Consumers  
Power  
Company

Re: Docket 50-155  
DPR-6 Z&K  
Proposed Tech Spec  
Change 23

Request for Change to the Technical Specifications

Change No 23

Figure 8.5  
BIG ROCK POINT F FUEL  
WITH INSTRUMENTED FUEL ROD

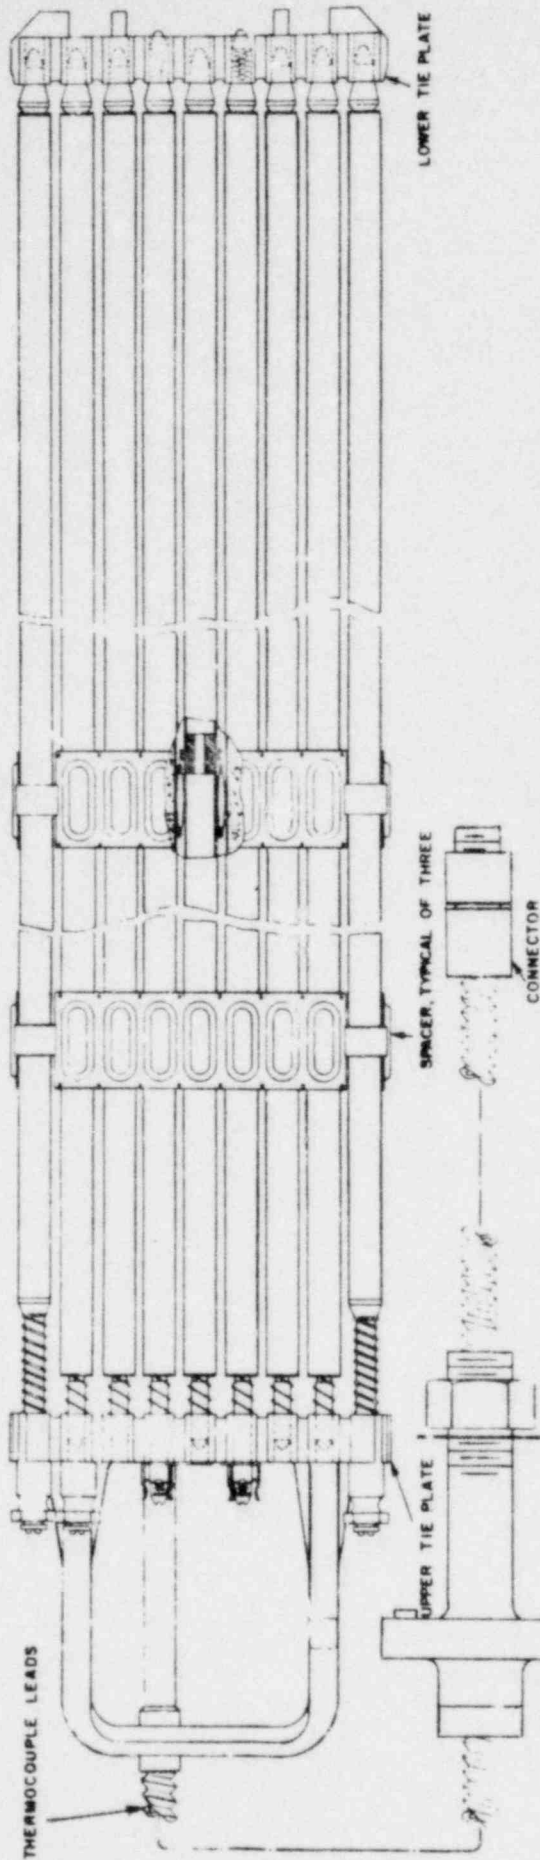
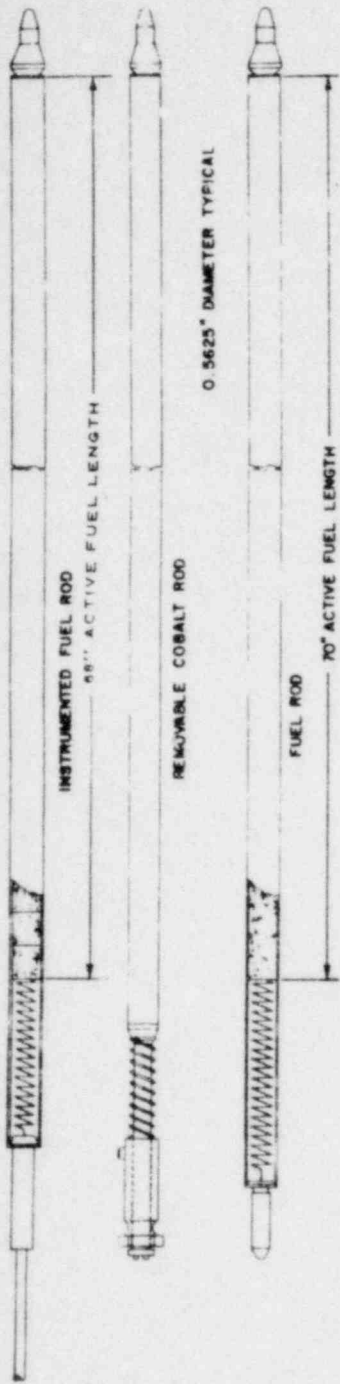
- B. In Section 8.1, add Figure 8.5, Big Rock Point F Fuel with Instrumented Fuel Rod.

- S - SPACER CAPTURE ROD (HIGH ENRICHMENT)
- H - HIGH ENRICHMENT RODS
- M - MIDDLE ENRICHMENT RODS
- T - TIE RODS (MIDDLE ENRICHMENT)
- L - LOW ENRICHMENT POWER CORRECTION RODS
- C - REMOVABLE COBALT RODS
- R - REMOVABLE FUEL RODS (MIDDLE ENRICHMENT)
- G - GADOLINIA RODS (MIDDLE ENRICHMENT)
- I - INSTRUMENTED FUEL RODS (MIDDLE ENRICHMENT)

**BIG ROCK POINT REACTOR  
INSTRUMENTED FUEL ROD  
FOR TYPE F BUNDLE  
FIGURE 1**

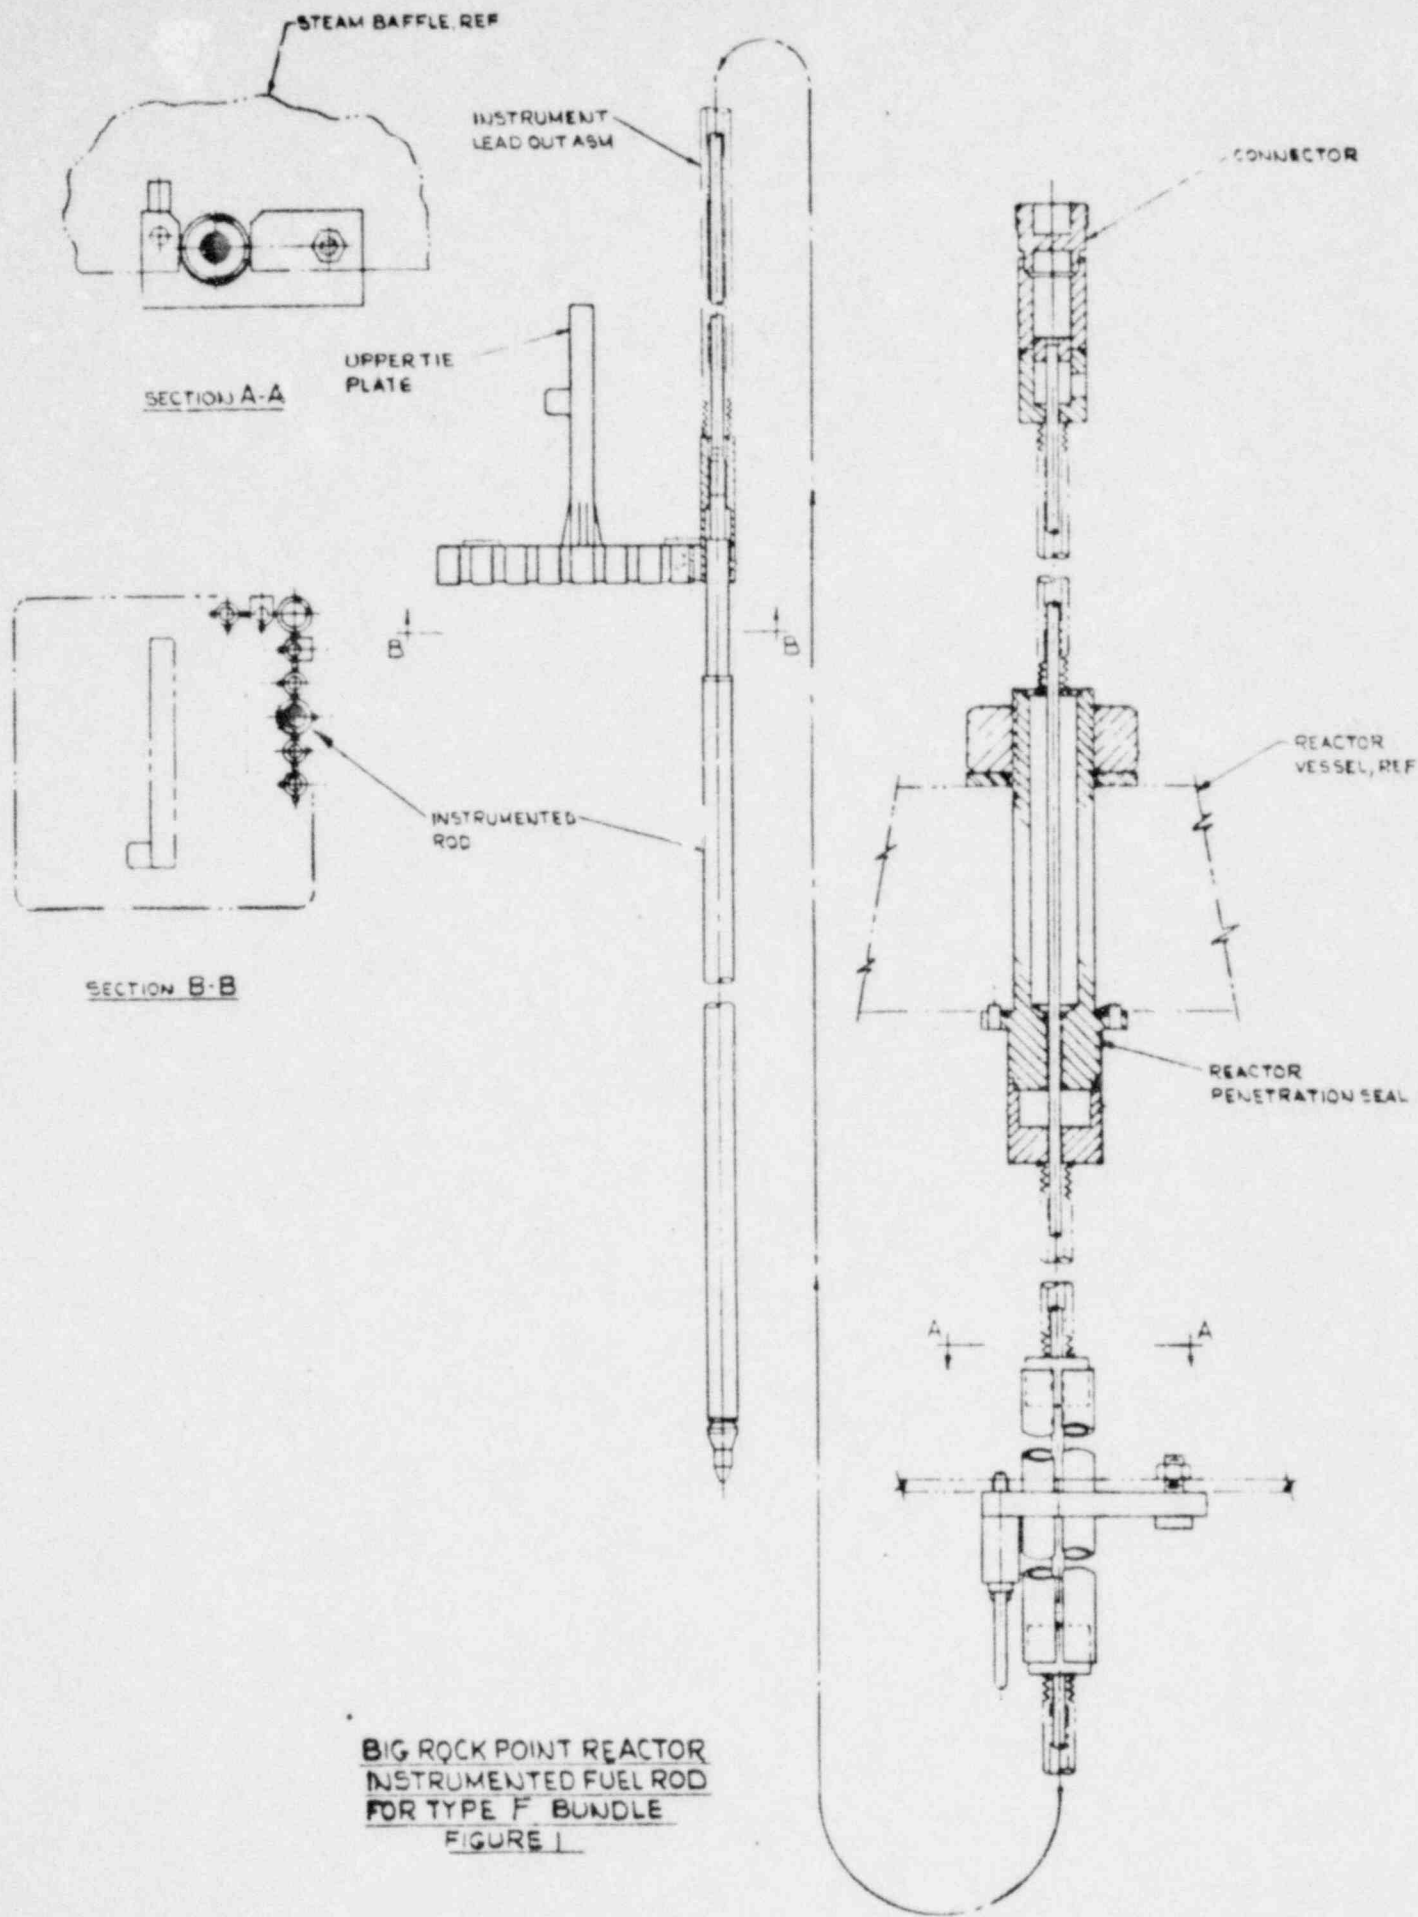
1. A standard type-F upper tie-plate will be modified. The modification will consist of the addition of a sleeve which permits extension of thermocouple leads through the tie-plate. The modification will not interfere with the function of the tie-plate as a structural element and will not affect nuclear or thermal-hydraulic characteristics of the bundle.

- 2. The upper end-plug of the fuel rod will be changed to permit extension of thermocouples out of the fuel rod. A tandem-extruded Zr-2 to stainless steel transition will be welded to the end-plug. Thermocouples will extend through the end-plug and transition and be sealed in a stainless steel over-sheath. The over-sheath will be welded to the Zr-2 to stainless transition. The over-sheath and thermocouples are part of the lead-out assembly which will extend from the instrumented fuel rod to the reactor head.

- 3. Thickness of the fuel cladding will be increased to 0.060 in. Axial grooves will be cut on the inner surface of the cladding. Stress analyses of the cladding for the instrumented fuel rod indicate that cladding integrity will not be compromised by the use of thick wall tubing and the presence of axial grooves.

- 4. The diameter of the UO<sub>2</sub> pellets in the instrumented fuel rod is less than the diameter of Reload-F fuel. Fuel enrichment will be increased so that the power factors for the instrumented rod are nearly equal to standard F fuel.
